Technical Service Bulletin

Number TSB-TM1-1

Date: 7/27/25

TM1/TM EZTune:

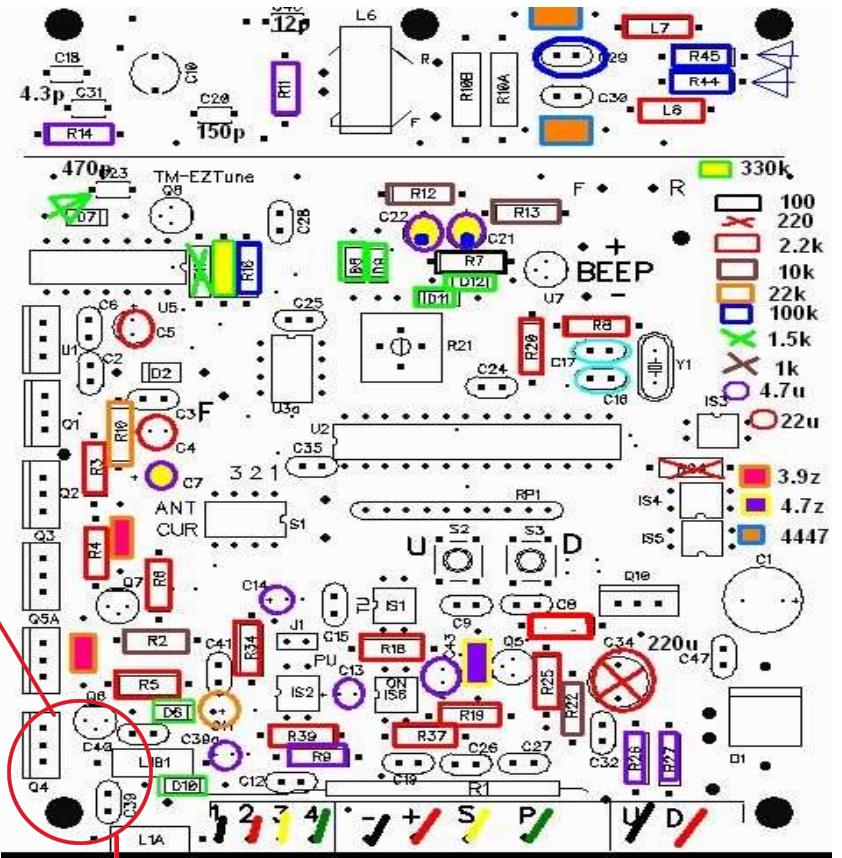
To eliminate the possibility of the output driver oscillating. This issue may or may not occur, but it is recommended to perform the service to eliminate any potential effects. This oscillation can cause overheating of the output driver MOSFETS in affected products, which can damage the parts, including burned components and failures causing the main power fuse to blow. Once damaged, the MOSFETS would need to be replaced. This bulletin eliminates this potential issue.

Removal of ceramic output capacitors on both output leads eliminates the oscillation. These can be either unsoldered, or force-removed with a small pliers (being careful not to leave excess wire tails remaining on board). After removing the parts, clear any remaining debris.

- 1) Remove rear panel by removing four(4) #6-32 flathead screws from rear of unit.
- 2) Locate C39 & C40 (located near the output chokes), and remove with cutters or pliers, completely removing all debris, and making sure no leads remain.
- 3) Re-attach rear panel.
